TOWN OF GILBERT

ADDENDUM NO. 3

Project Name: Reservoir, Pump Station and Well Conversion
CIP Project Number: WA0620
Contract Number: 319001048

June 06, 2019

**WA0620 SPOIL LOCATION EXHIBIT
NOT TO SCALE DATE 5-30-19**

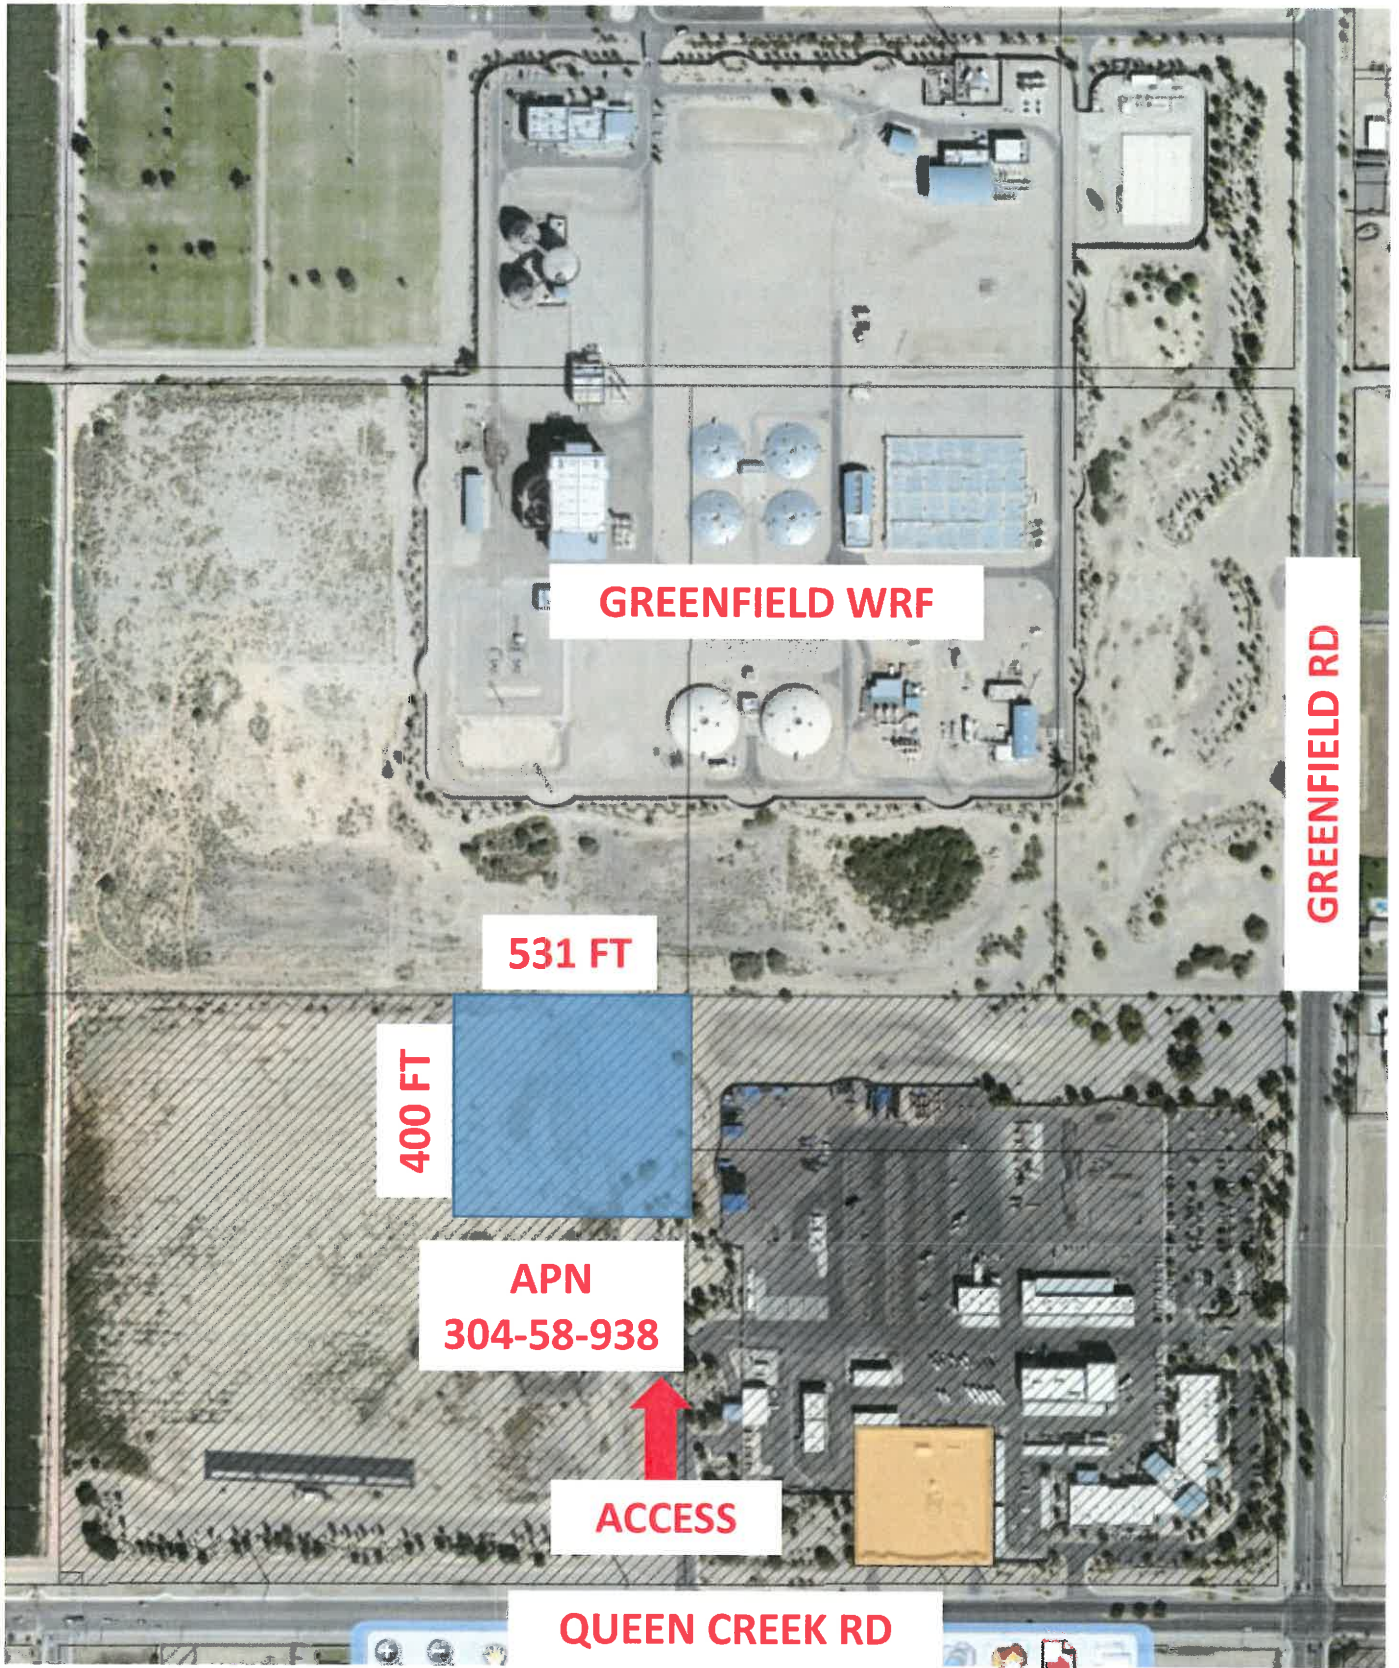
Add: The Town has secured and will make available to the CONTRACTOR for soil storage an area on a Town owned parcel located west of the northwest corner of Greenfield Rd and Ocotillo Rd. This area is defined as a new Temporary Spoil Location on parcel 304-58-938 to be referred to as the **Parcel 304-58-938 WA0620 Spoil Location**. It is intended the CONTRACTOR shall utilize this land for soil storage of material excavated for construction of the proposed reservoir. Use of this area shall be reflected in the bidders cost for Soil Haul-Off (This Item) and Soil Haul-Back (Bid Item 7). An Exhibit for this area is attached. CONTRACTOR shall follow TCE Requirements as described in SC-2.05.00 for use of this land.

The area indicated on the exhibit will be made available to the Contractor during Construction with the following requirements:

- a) Site ingress and egress will be from Queen Creek Road.

- b) Any soil placed on this site must be clean of any organics, construction or waste materials in accordance with the Construction Documents.
 - c) At substantial completion the CONTRACTOR will grade the area to a maximum added grade of 1 foot in elevation that has been bladed and will have a 10 feet wide drive around the perimeter, within the area footprint shown in the exhibit that is suitable for truck traffic. The soil placed shall not adversely affect existing onsite and offsite drainage. Any additional material required shall be at no cost to GILBERT. CONTRACTOR shall obtain survey elevation shots prior to excavation and after restoration to provide to GILBERT's representative to confirm conditions are established as described above.

- d) During construction, prior to substantial completion the stock pile area will have a 10-foot-wide drive around the perimeter, within the area footprint shown in the exhibit that is suitable for truck traffic. The soil will have a maximum 10-foot height and 4-foot horizontal to 1-foot vertical slope. The soil placed will not adversely affect existing onsite and offsite drainage.
